Technical Specification Bulletin		TB03
Fuel Type	Date	Edition
Oil	June 2019	3

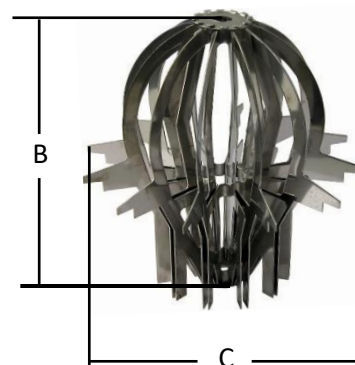
The 8-inch catalyser was redesigned in 2018 and the number of veins was reduced to stop carbon building up between them, which increases its life.

The 339 catalyser can be replaced using the new 26428 in the 8 & 10 inch twin skin burner.
